SIB 52 04 21

RECALL 21V-156: OUTER HEADREST SECOND ROW

This Service Information Bulletin (Revision 3) replaces SI B52 04 21 **dated March 9, 2021**.

- Recall # added to SIB title
- Inspection Procedure clarification

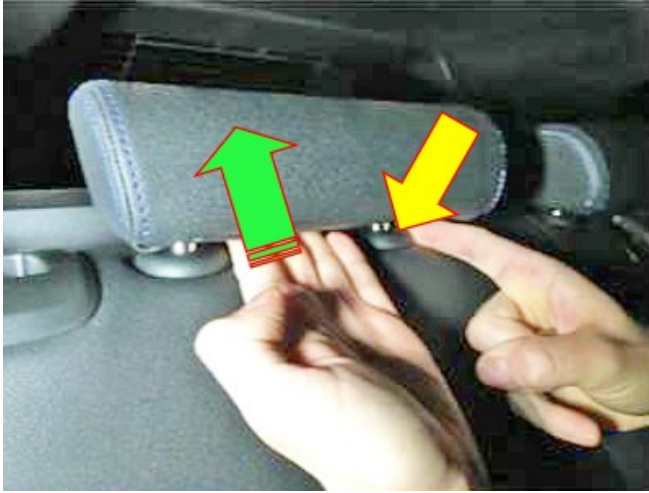
Left and right outer headrests may have been installed which do not have a positive stop movement limiter at their highest position.

During a frontal impact, unsecured items (e.g., luggage) in the rear could move forward and contact the rear seat, which could cause the headrest to detach from the seat.

Check each headrest for the presence of the positive stop. If missing, replace the headrest.

1. On either outer headrest, squeeze the headrest height release button (yellow arrow) at the seatback top retaining collar.

The photo shows a 5th notch (circled) but this does not matter because the headrest was easily pulled out. That is the main criteria for a Not OK headrest.
